# CITY OF ALBUQUERQUE

**RE: Lots 16 Block 4 Volcano Cliffs Unit 22 SAD 228  
6427 Canavio Pl. NW.  
Grading and Drainage Plan  
Engineers Stamp Date; 12/2/2021 (D10D003D16)  
Pad Certification Date; 2/24/2022  
CO Certification Date; 9/28/2022**

## DRAINAGE AND TRANSPORTATION INFORMATION SHEET (REV 6/2018)

HASLAM, VINCENT (CANDELARIA HOMES) - G & D PLAN

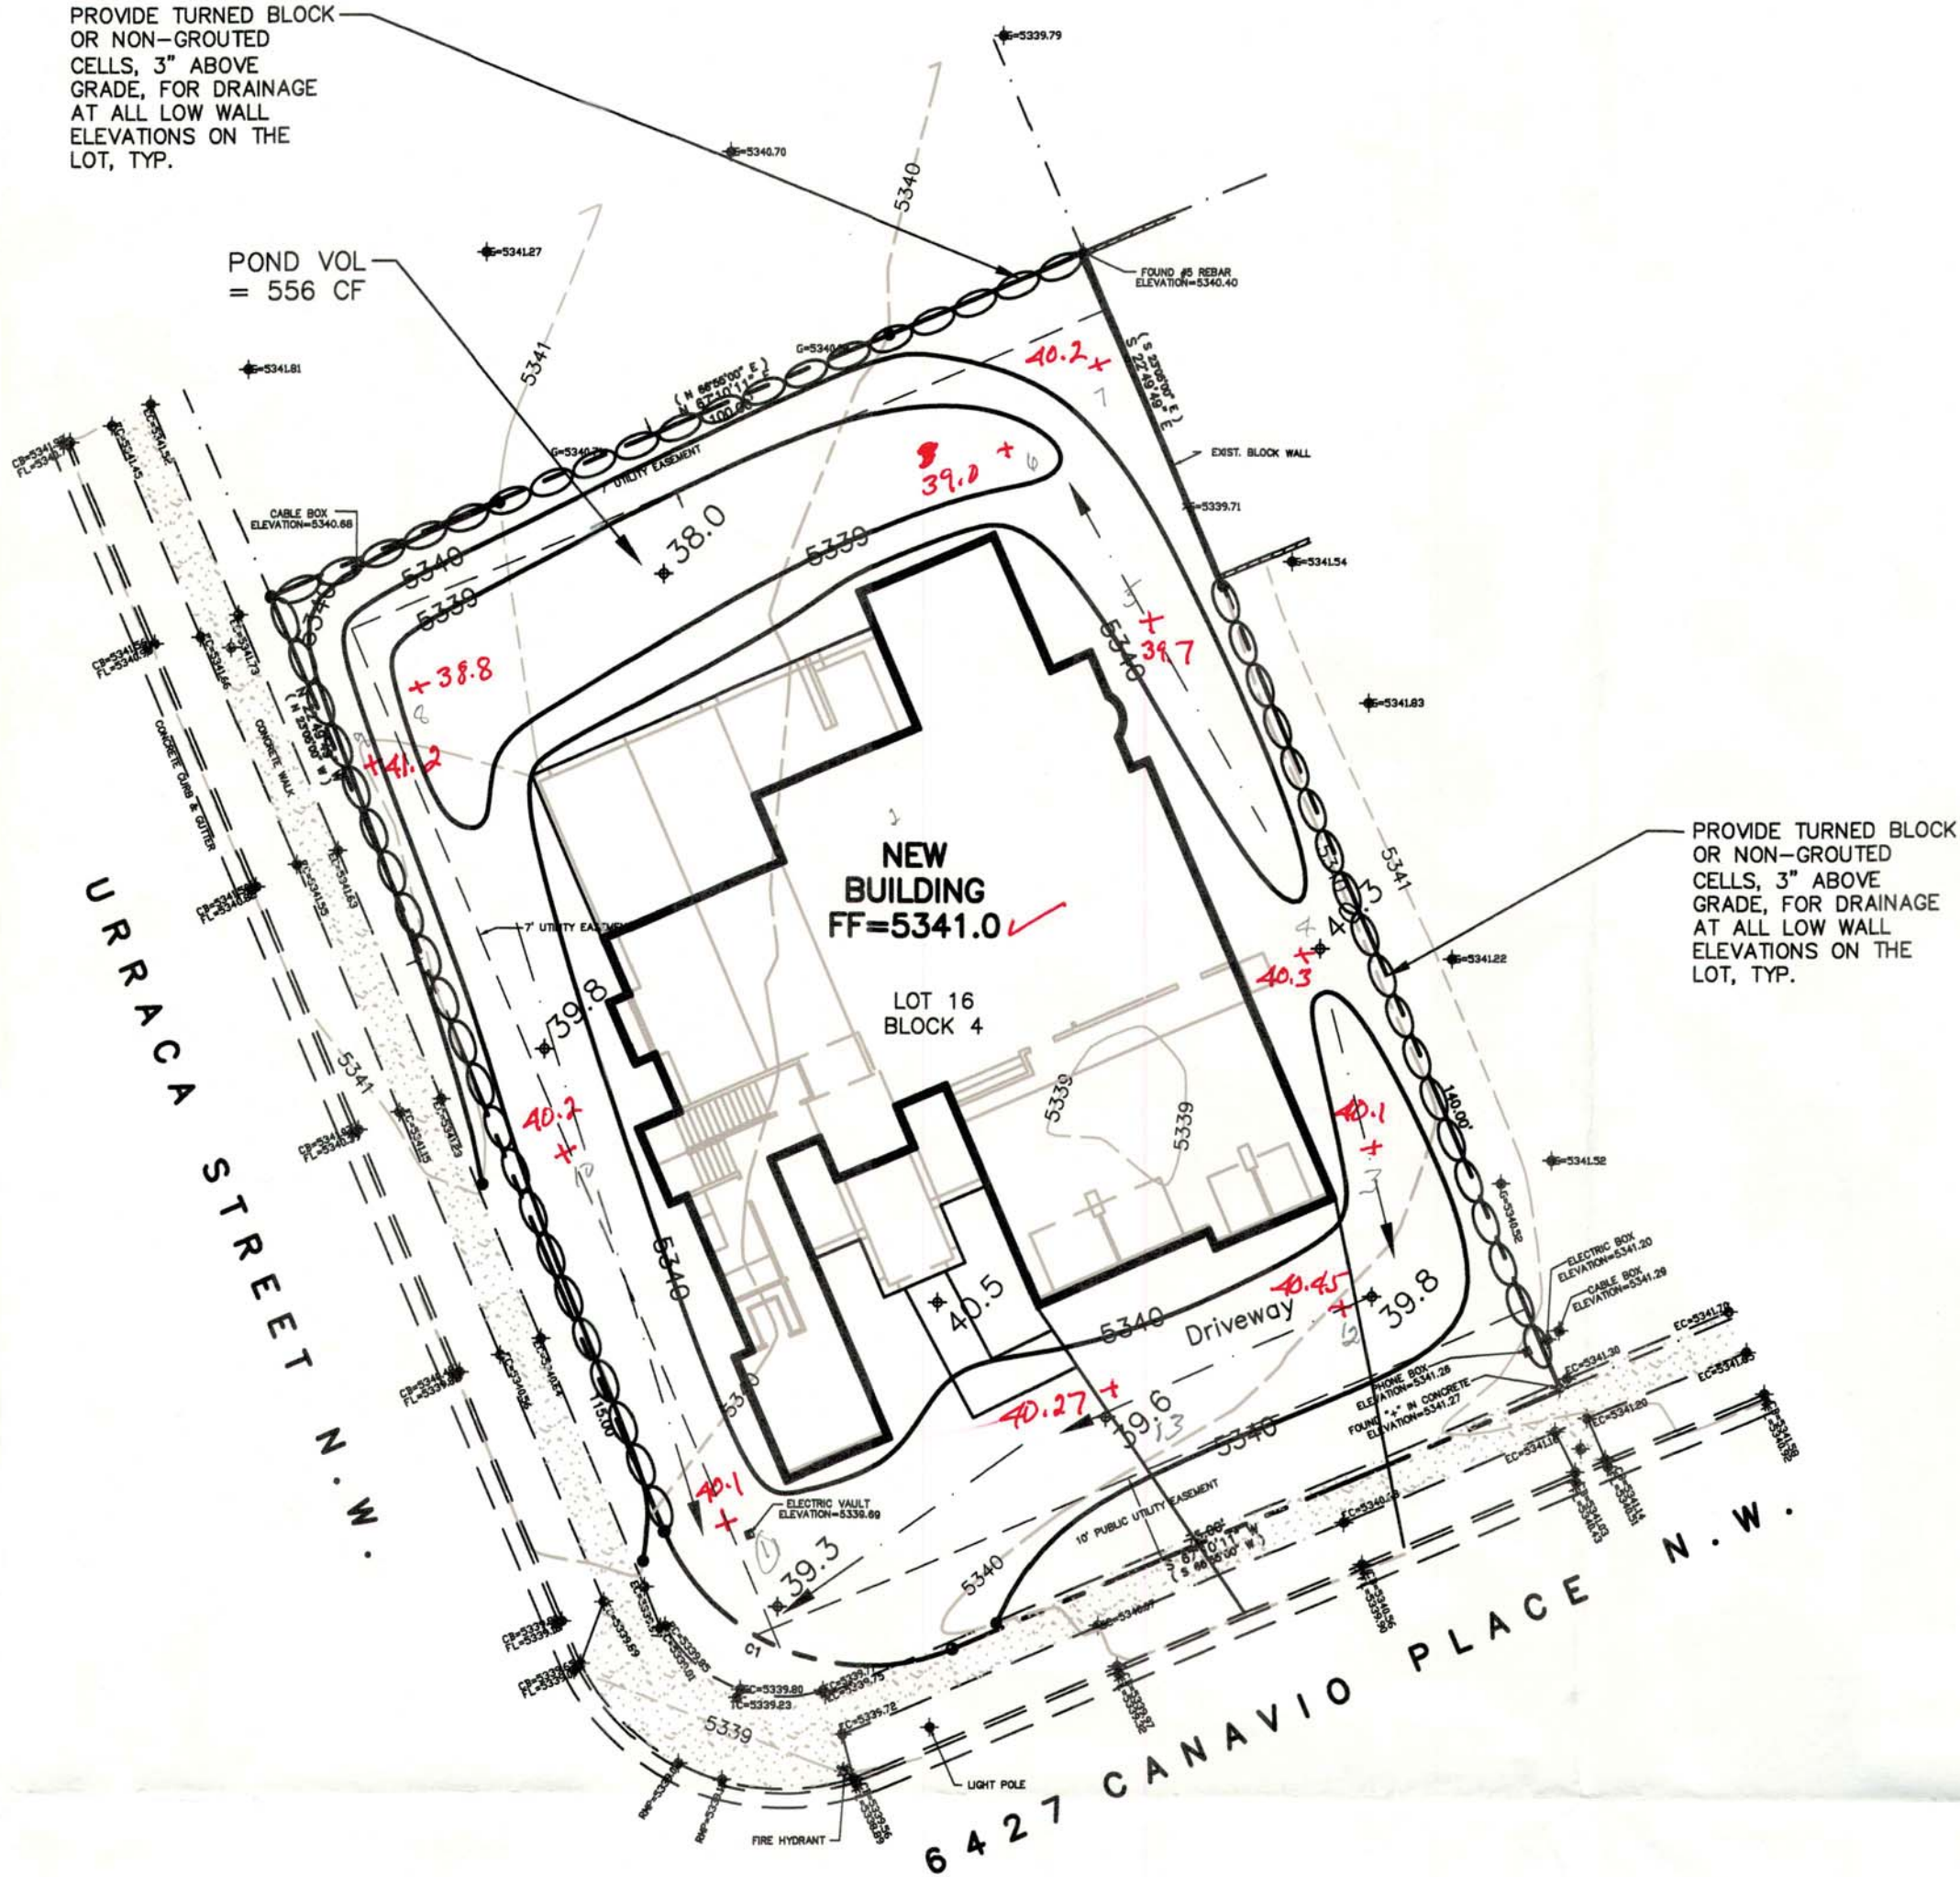
- All construction material in and around the home needs to be removed including the port-a-potty.
- Block wall being placed from property line to home south side needs to have a turn block to allow for flows to exit to the front yard. If this is not the case, flows need to be shown as being retained in the rear yard and if pond has sufficient capacity.
